A drip chamber in a cerebral spinal fluid (CSF) drainage system comprising:  
a tube having an outer surface; and,  
a vent in fluid communication with the tube, the vent having a filter made of a porous material, the pore size of the filter ranging from greater than .45  $\mu\text{m}$  to about 5.0  $\mu\text{m}$ , the filter being flush with the outer surface of the tube.

#### REMARKS

Claims 1, 3 and 5 have been amended, claims 2, 7 and 13 – 23 have been canceled without prejudice and claims 62 - 73 have been added. Claims 1, 3 – 6, 8 - 12 and 24 -73 remain pending in the application. The Examiner is respectfully requested to re-consider his rejections.

Fig. 5

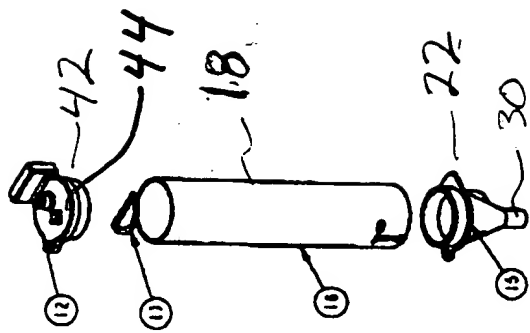
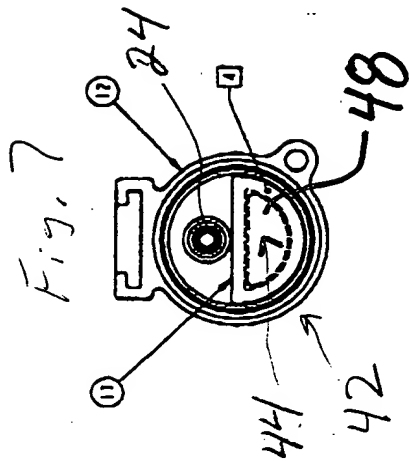
The Examiner has objected to the drawings under 37 C.F.R. 1.83(a) because they fail to show "the filter being flush with the outer surface of the volume reservoir" as described in the claims. Submitted herewith is a redline version of Figure 5 with the label "44" added to show the location of the filter material 44. Support for this addition is found in Figures 6 and 7. As can be seen, filter material 44 is flush with the outer surface of the volume reservoir. No new matter has been added. Therefore, the Examiner is respectfully requested to reconsider his '83(a) objection. Should the Examiner accept the submitted redline versions of Figures 5 and 7, the Applicant will prepare and submit formal drawings for the instant application incorporating the proposed changes.
